Memorandum

TO: Clackamas County Historic Review Board

SUBJECT: MISC 10-04, 1892 4th Avenue

Change C

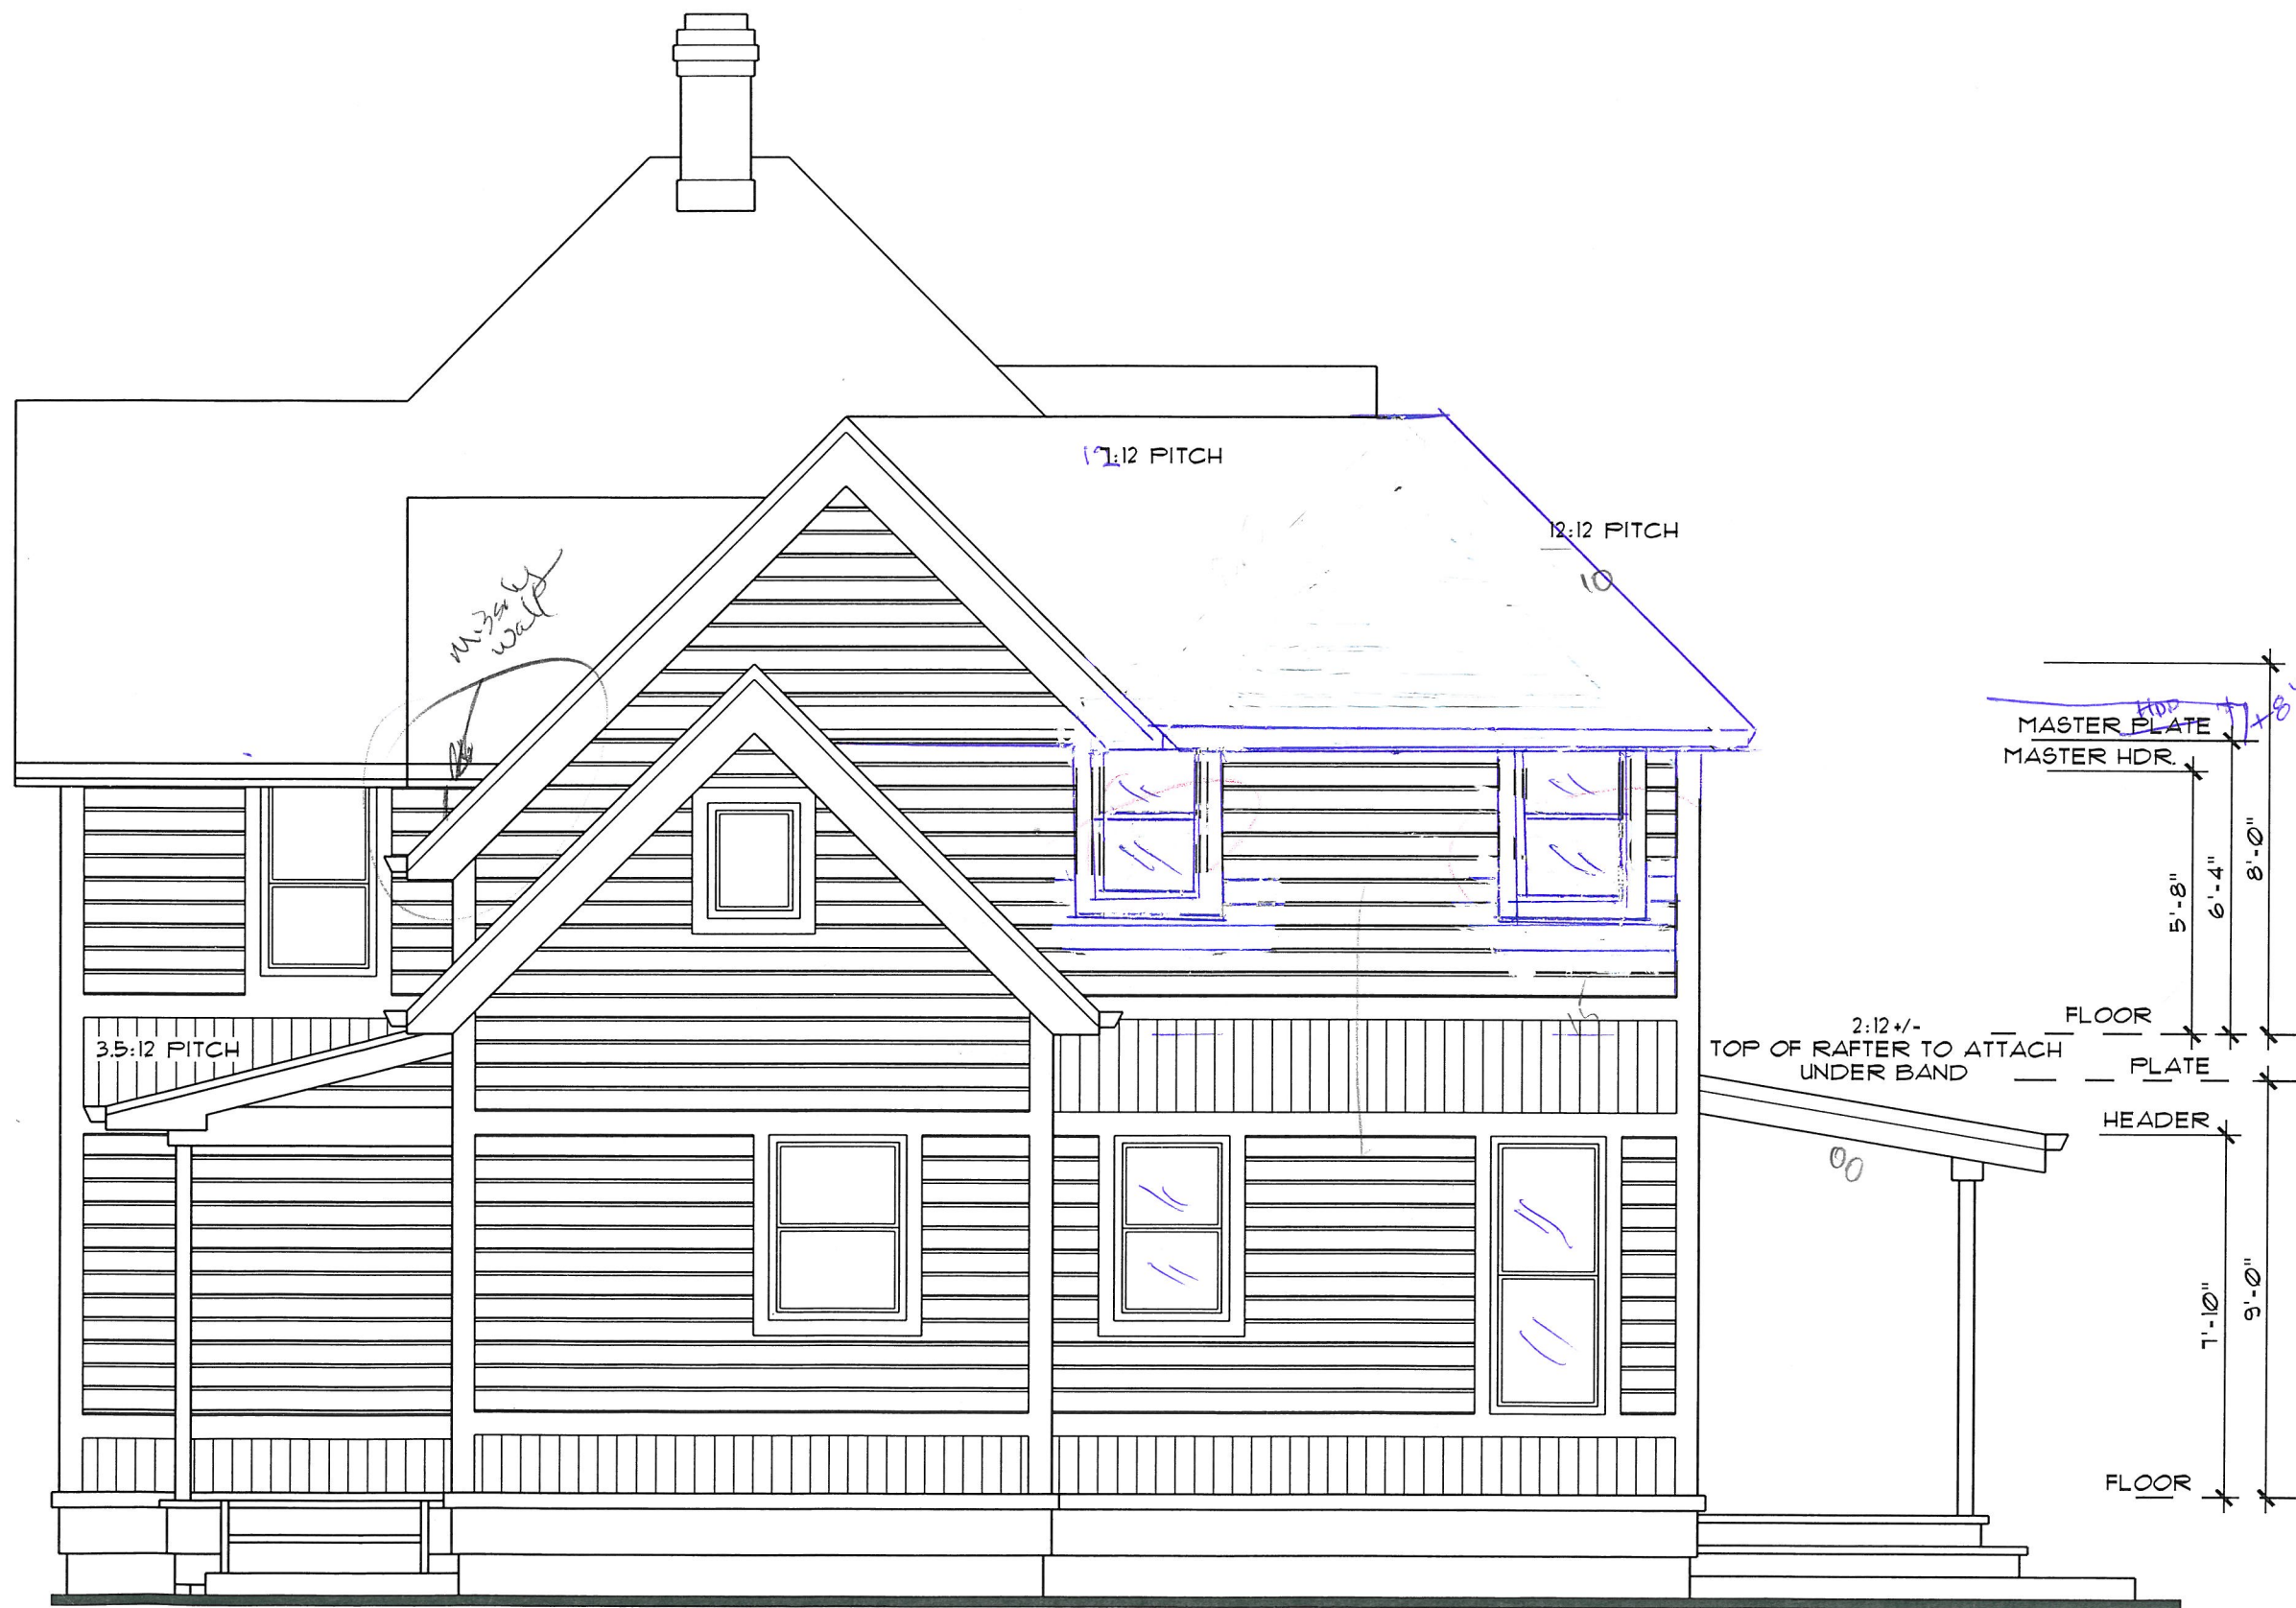
Attached are revised plans submitted by the applicant for his residence at 1892 4th Avenue. The revised plans increase the height of the wall on the second floor approximately 6"-8" to allow for the height and area required for egress windows by building code and fire and life safety regulations. With these plans, the roof pitch, number of gables, and windows on the rear of the house remain as originally approved.

* Windows
 5'-1" x 3'-4"
 meet National
 egress Code
